**Summary of Proposed Amendments to the Trent Source
Protection Plan and Assessment Report – King’s Bay
Drinking Water System**

*Pursuant to Section 34 of Ontario Regulation 287/07 of the Clean Water
Act*

The City of Kawartha Lakes is revising the Wellhead Protection Area (WHPA) for the King’s Bay Drinking Water System (DWS) due to the installation of a new well. These upgrades have resulted in the Proposed Amendments to the Trent Source Protection Plan (SPP) and Assessment Report (AR) (last updated and approved DATE) listed below and summarized and highlighted in yellow on the following pages. A strike-through indicates that text is to be removed.

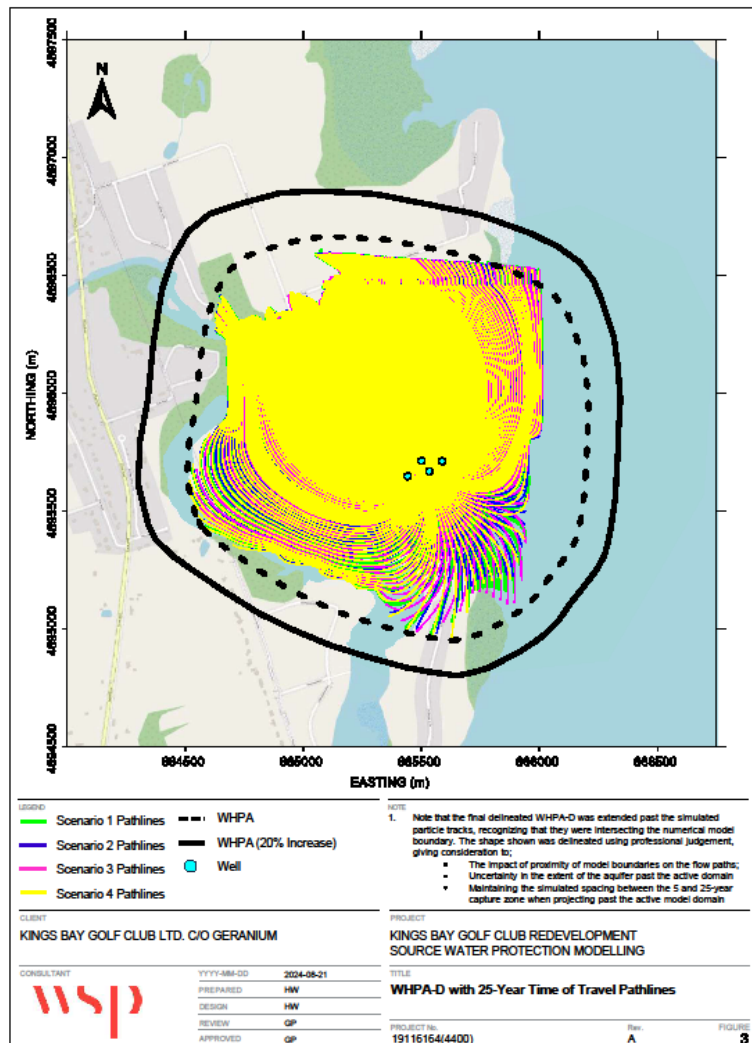
The final delineated WHPA-D was extended past the simulated particle tracks, recognizing that they were intersecting the numerical model boundary. The simulated particle tracks reach the river on the west side of the wells, and the lake on the east side of the wells, and do not travel past these features as the model grid past this point is inactive. The final WHPA-D shape adopted was delineated using professional judgement, giving consideration to:

1. The impact of proximity of model boundaries on the flow paths and travel times;
2. Uncertainty in the extent of the aquifer past the active model domain; and
3. Maintaining the simulated spacing between the 5 and 25-year capture zones when projecting past the active model domain (i.e. river to the west, lake to the east)

A figure illustrating the 25-year time-of-travel capture zone is shown below. The figure shows the time of travel particle tracks for all four scenarios along with the outline of the capture zone and the outline of the capture zone with the factor of safety applied.
